SAWS 2021 CMOM Package 6 – Open Cut and Pipe Burst
Solicitation Number: CO-00713
Job No.: 22-4510

ADDENDUM 5
December 28, 2023

MAP NO. 140576 SHEET 24
SECT. NO. _____ OF 144

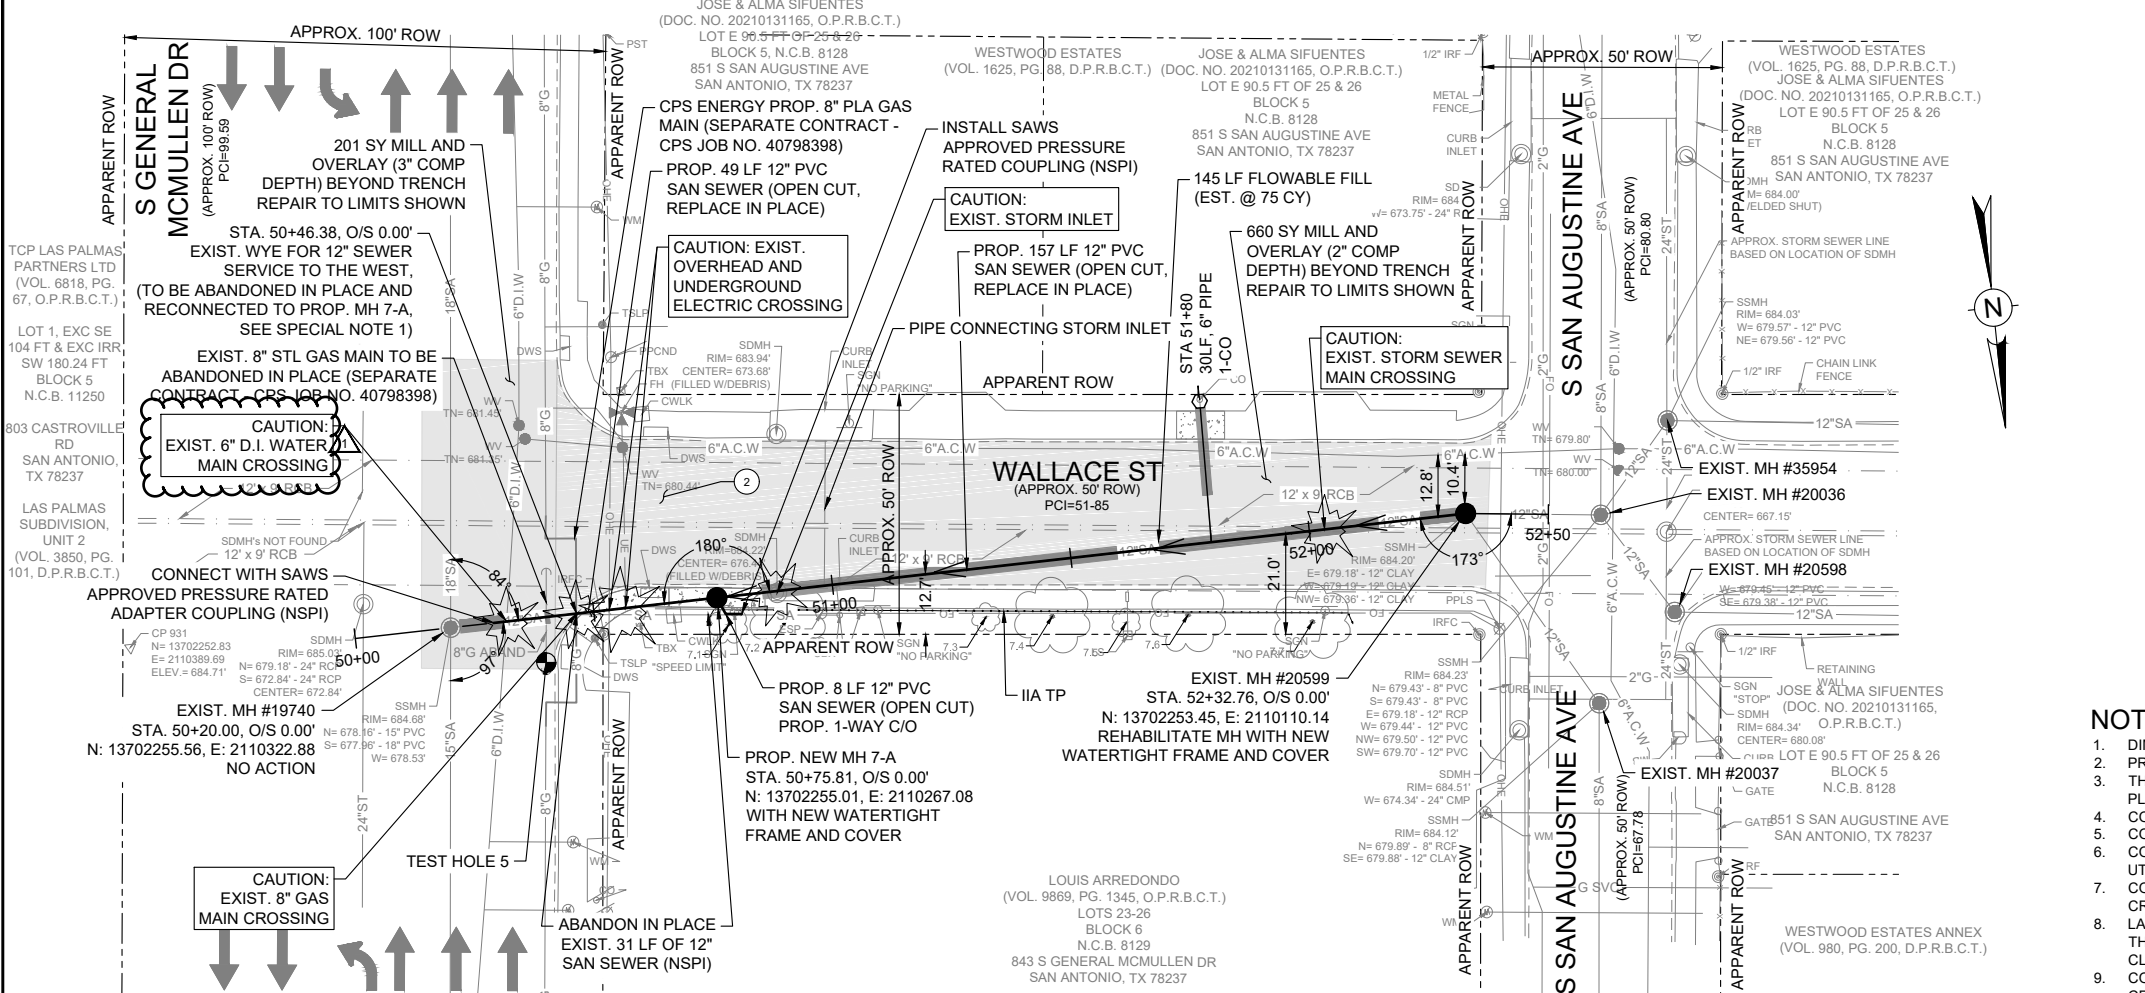
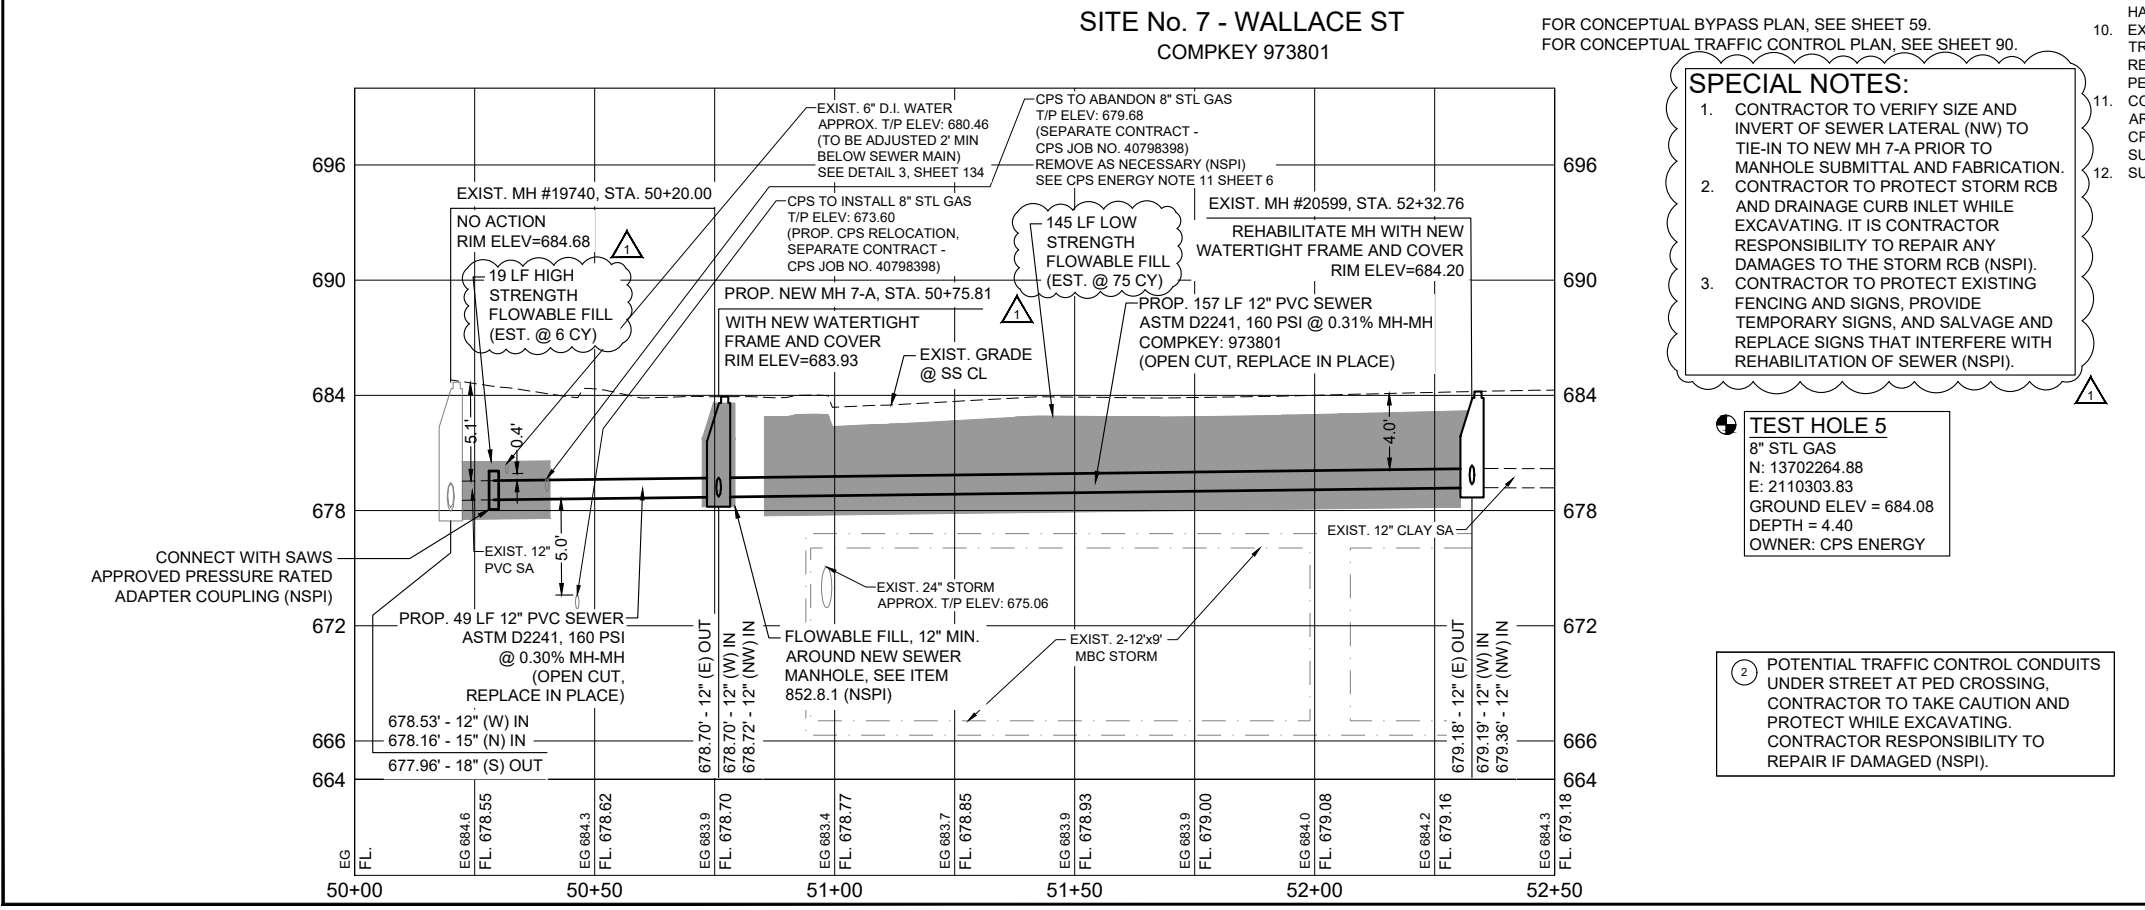
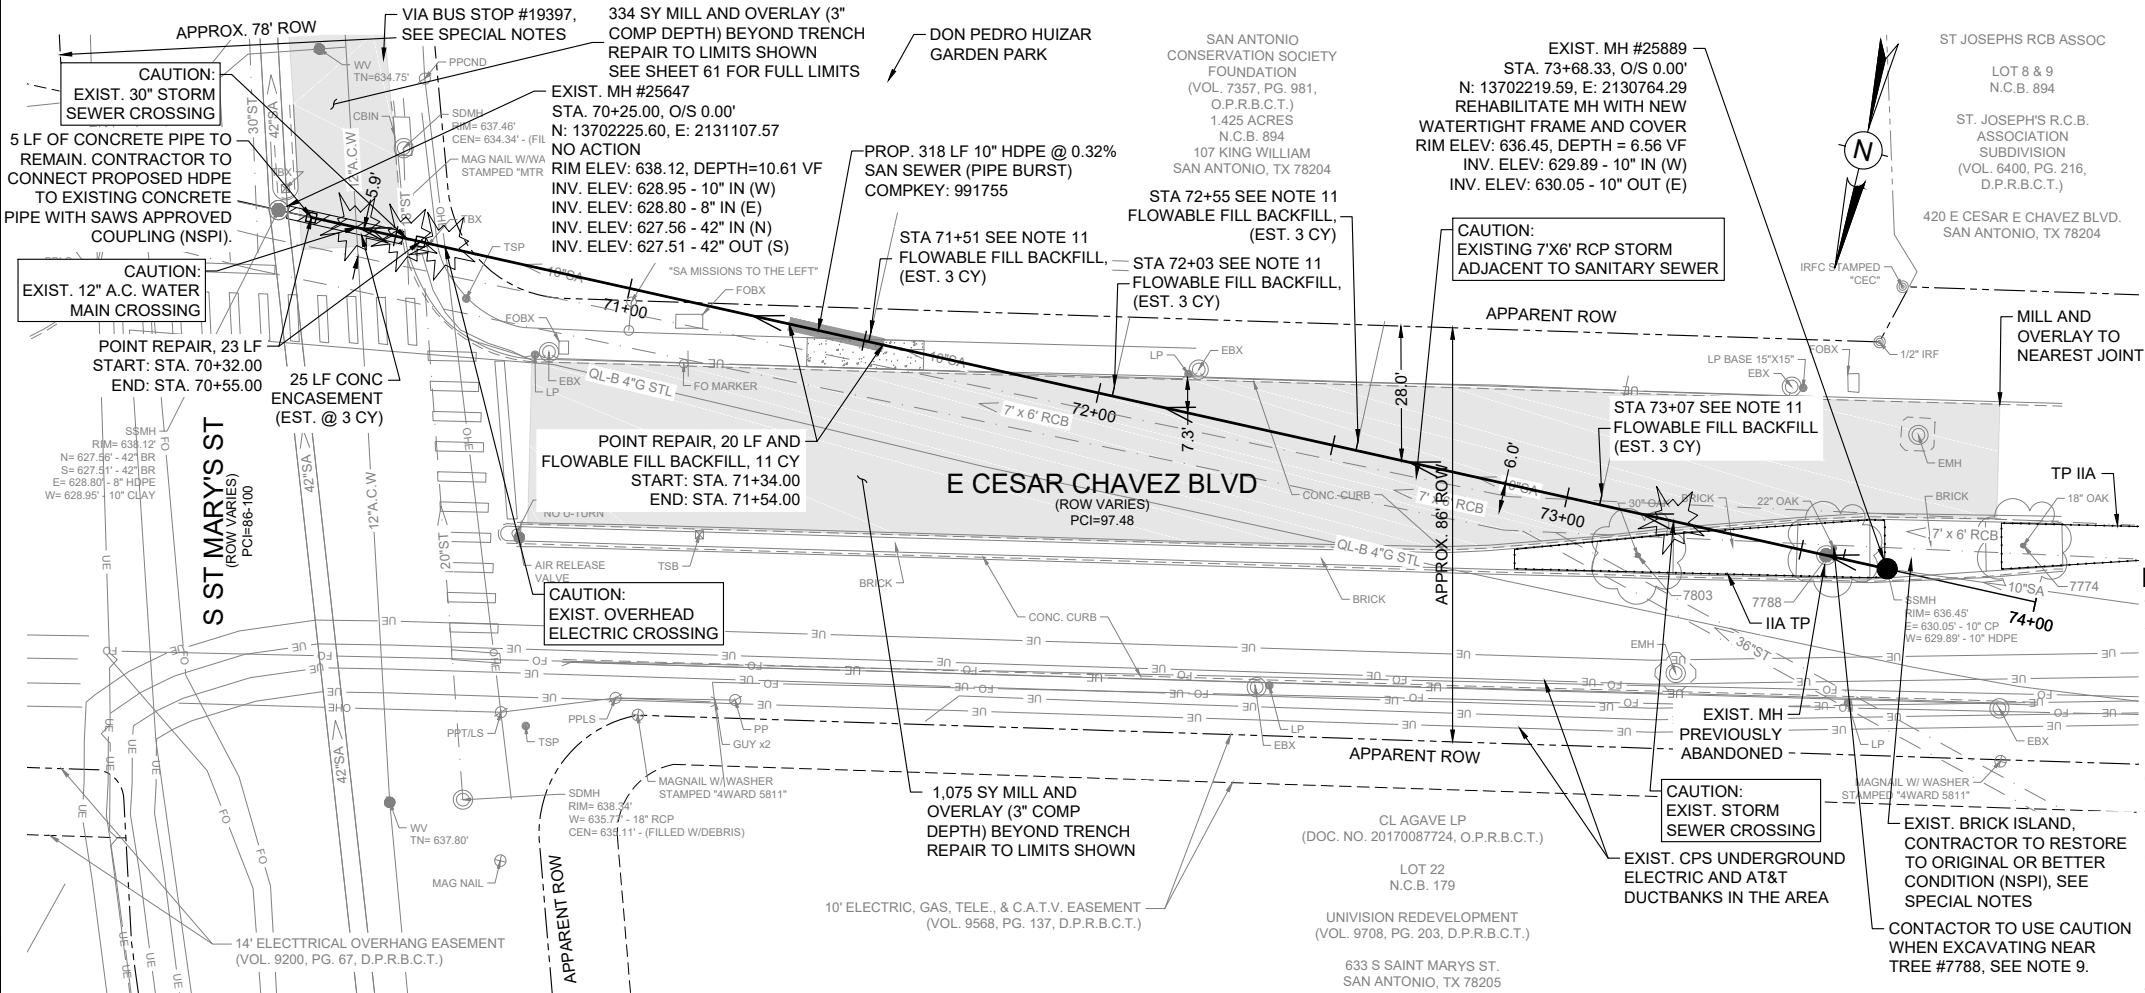
1. **SHEETS 3, 24, 27, 29, 30, 33, 42, 45 and 54:** Remove sheets 3, 24, 27, 29, 30, 33, 42, 45 and 54 from the Plans and replace with the attached Sheets 3, 24, 27, 29, 30, 33, 42, 45 and 54. The changes include revisions to the Quantity Summary Table, Special Notes, lateral location, flowable fill (high strength) quantity, and existing water elevation.
